AW-97-1118

June 10, 1997

SUBJECT: RESPONSES TO OPEN ITEMS ON WCOBRA/TRAC APPLICABILITY TO
AP600 LARGE-BREAK LOSS-OF-COOLANT ACCIDENT

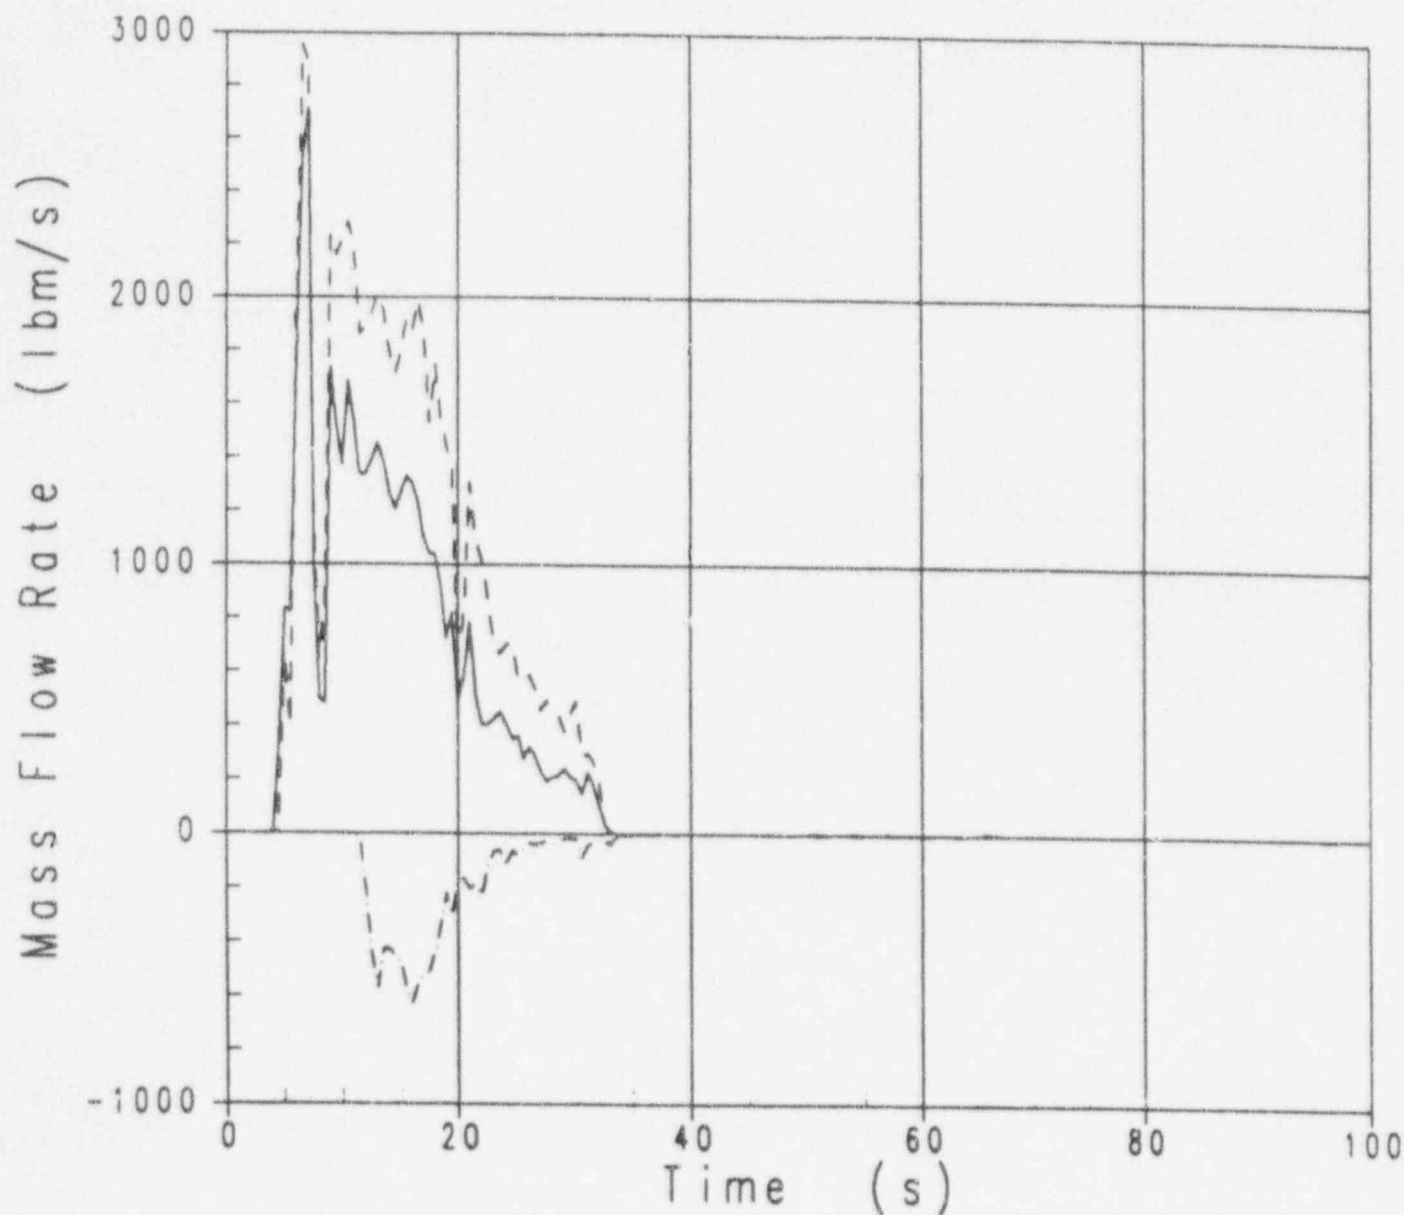
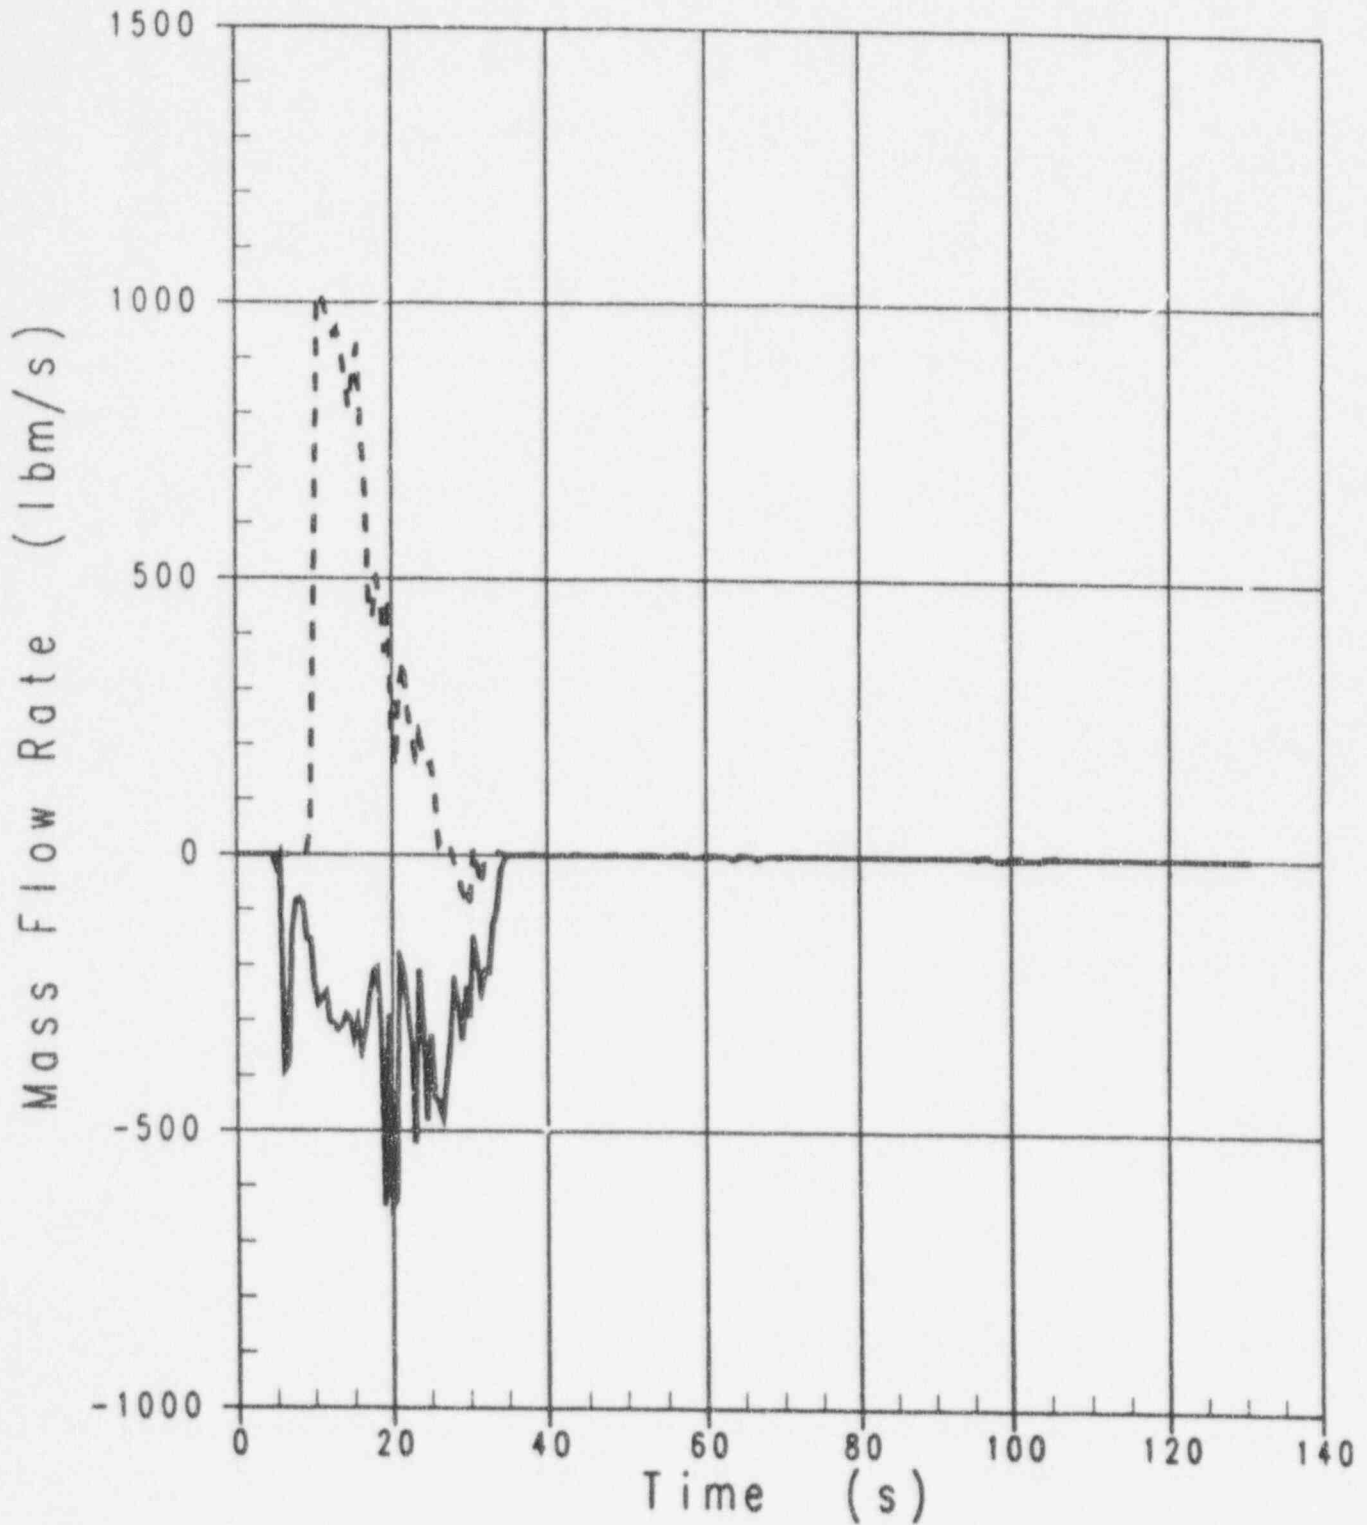
- c. Westinghouse ranked downcomer entrainment/deentrainment slightly lower in reflood for the AP600 relative to 3-/4-loop plants but did not discuss why. Clarify the reason for the lower AP600 ranking. If the reason(s) is(are) similar to that discussed in part a, provide the same type of information requested in parts a and b.

The AP600 PIRT shows a lower ranking for downcomer entrainment because it is less important during reflood for AP600 large break LOCA events than it is for 3/4-loop plants. Two phenomena which can lead to liquid entrainment (and deentrainment) in 3/4-loop plants do not apply to AP600. First, the direct vessel injection of accumulator water and the very large accumulators with which the AP600 is equipped mean that no downcomer boiling occurs in AP600 during the time of interest for the calculation of peak cladding temperature. Second, the elevation of the DVI nozzle entrance into the AP600 downcomer is about two feet below the bottom cold leg elevation, and the downcomer is equipped with flow diverters to direct safety injection water downward toward the lower plenum. The safety injection water is not subject to surface entrainment into any high velocity steam which might be progressing from the intact loop cold legs across the downcomer to the break.

The attached Figure 1.c-1 plots the entrained liquid flow predicted between cells in COBRA downcomer channel #56, which is connected to the broken cold leg, in the AP600 WCOBRA/TRAC CD = 0.8 DECLG analysis presented in Chapter 2 of WCAP-14171, Revision 1. FEM (56,1) is the entrained droplet flow into the channel's lower cell from the channel below, and FEM(56,3) is the entrained droplet flow out of the channel upper cell, which is connected to the broken cold leg, into the channel above. FEM(56,2) shows the flow between the two cells of channel 56. The figure illustrates that although as much as 3000 lbm/sec of entrained liquid flows into the cell connected to the break during blowdown, there is almost no entrained liquid entering into that downcomer cell from adjacent cells to proceed out the break during reflood. Further, Figure 1.c-2 presents the entrained droplet flowrates in the gaps connecting channel 56 and adjacent channels 55 and 57. The flow direction is into channel 56 in both gaps. Again, after the end of blowdown the droplet flow through these gaps is insignificant. For the reasons specified in the first paragraph, downcomer entrainment during reflood is not as important during reflood for AP600 as it is for 3/4 loop plants.

AP600 LBLOCA WC/T CAD CASE 0: DECLG. CD=0.8. T_{min}=800F. WITH PXS
 Figure 1d-1: Vessel Upper Plenum to Hot Legs Flows A Flows - Blowdown

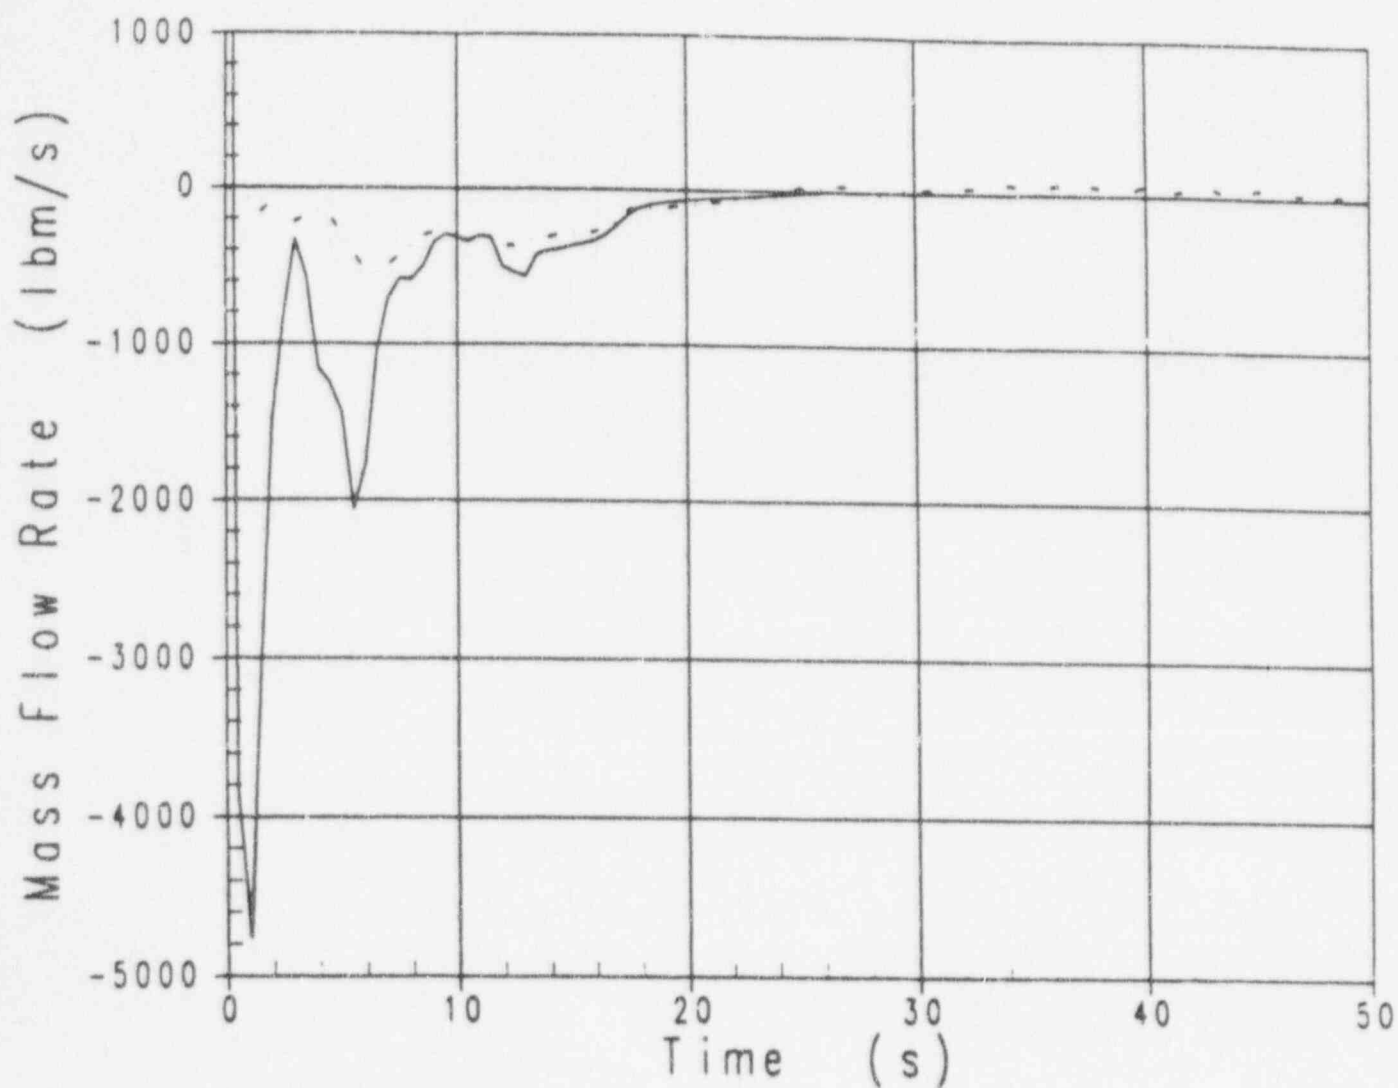
- d. On page 2-8, Westinghouse discussed flow from the upper plenum to the core during flow reversal in blowdown. During the flow reversal, Westinghouse argued that all the upper head water flows to the upper plenum and then to the core due to the large pressure drop between the upper plenum and the break. However, the flow path to the break through the hot leg is another possible route for upper head water. To clarify the flow split from the upper plenum to the core versus the upper plenum to the hot legs, provide plots of the flows at the intact and broken loop hot leg junctions for comparison to the top of the core flows provided in Reference 1. Clarify how the hot leg flows support Westinghouse's position on the flow to the core or provide additional information to clarify Westinghouse's understanding of the flow split and how any uncertainty in the calculation is accounted for in the AP600 uncertainty analysis. This is a followup to Discussion Item 5b in the May 17, 1996, letter.

The attached Figures 1.d-1 and 2 depict the flow in the two hot legs at the junction of the vessel outer global channel during the AP600 blowdown. Early on, within the first second following the break, flow in the intact loop hot leg reverses and proceeds into the vessel. During the remainder of the 35 second blowdown, any liquid flowing at the intact loop hot leg/vessel junction flows into the vessel. During the initial seconds of the transient, the influx of liquid from the intact loop hot leg (Figure 1.d-1) into the upper plenum is far less than the flow through the broken loop hot leg (Figure 1.d-2). In the first second, liquid and entrained droplet flow into the outer global channel from the inner global channel through gap 58 contributes most of the rest of the large flow that feeds the break through the broken loop hot leg (Figure 1.d-3). The flow through both levels of gap 58 is from inner to outer global channel during the blowdown.

In the five to six second time frame, a portion of the influx from the intact loop hot leg enters the core as a downflow into the peripheral or guide tube fuel assemblies (WCAP-14171, Revision 1, Figures 2.2-34 and 2.2-36). This is apparent from Figure 1.d-4, the liquid flow at the elevation of the bottom of the hot leg in outer global channel #61. During the first few seconds the mass initially present in this channel drains. The inflection in the channel 61 downflow observed at 5-6 seconds is the net increase of approximately 700 lbm/sec being provided by the intact hot leg. Shortly after six seconds, the broken loop hot leg flow from the vessel once again exceeds the flow into the upper plenum from the broken loop hot leg, and the flow inflection in Figure 1.d-4 ends. Beyond 12 seconds, the liquid flow from the intact loop hot leg is in part predicted to enter the core, and in part proceeds out the broken loop hot leg as liquid and entrained droplets. This pattern continues until the liquid flow in each of the hot legs diminishes to a small value approximately 18 seconds into the transient.

AP600 LBLOCA WC/T CAD CASE 0: DECLG. CD=0.8. Tmin=800F. WITH PXS
 Figure 1(e): Core Hot Assembly Channel Outlet Flows (Reflood)

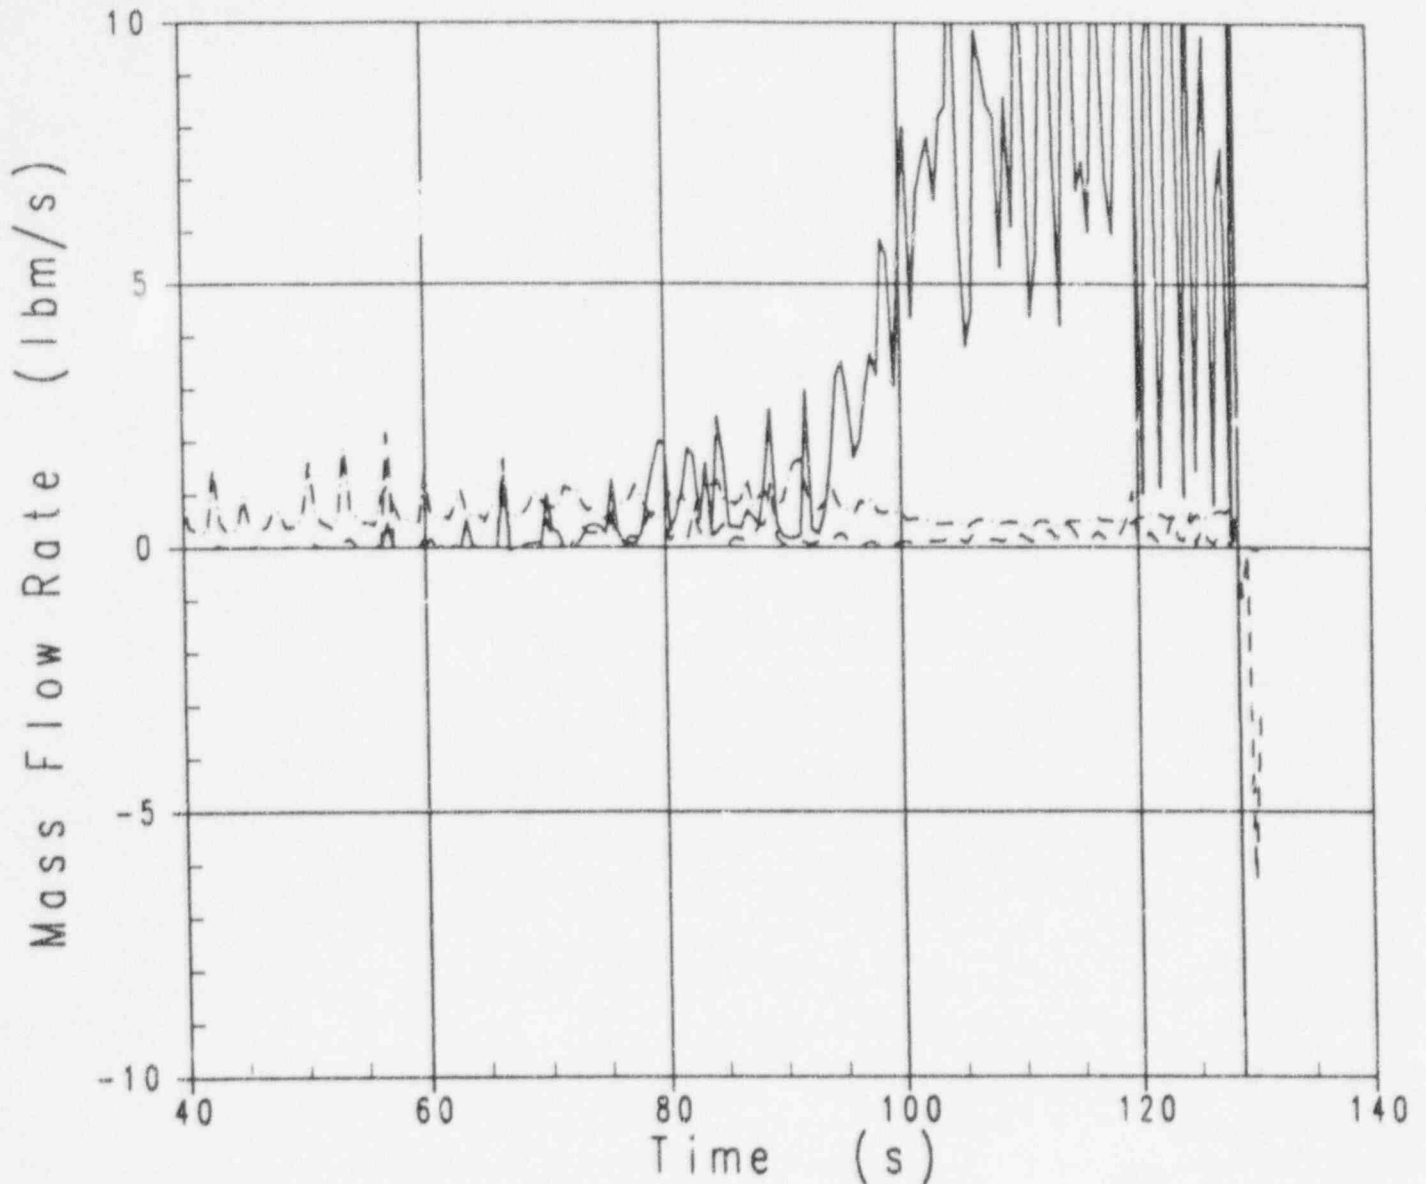
- e. For core countercurrent flow (CCF) during reflood, provide plots that show the flows calculated at the core outlet to clarify if downward liquid flow is calculated and contributes to core cooling. If yes, justify not ranking this phenomena or provide a ranking and its justification. If liquid flow downflow at the top of the core contributes to core cooling during reflood, clarify how the uncertainty in this phenomenon is accounted for in the AP600 uncertainty analysis.

Liquid downflow at the top of the core does not contribute to AP600 core cooling during reflood. Attached are figures which show the liquid, entrained droplet, and vapor flows predicted at the core outlet during the WCAP-14171, Revision 1 Section 2.2 DECLG break case for the hot assembly, guide tube, open hole/support column and peripheral channels. The figures show that during reflood, through the time of core quench, no significant downflow exists in any of the channels, except the peripheral channel. For the low power peripheral fuel channel, the downflow calculated begins almost 90 seconds into the transient, well after the reflood phase PCT has occurred. Therefore, core countercurrent flow during reflood is unimportant and need not be included among the ranked phenomena.
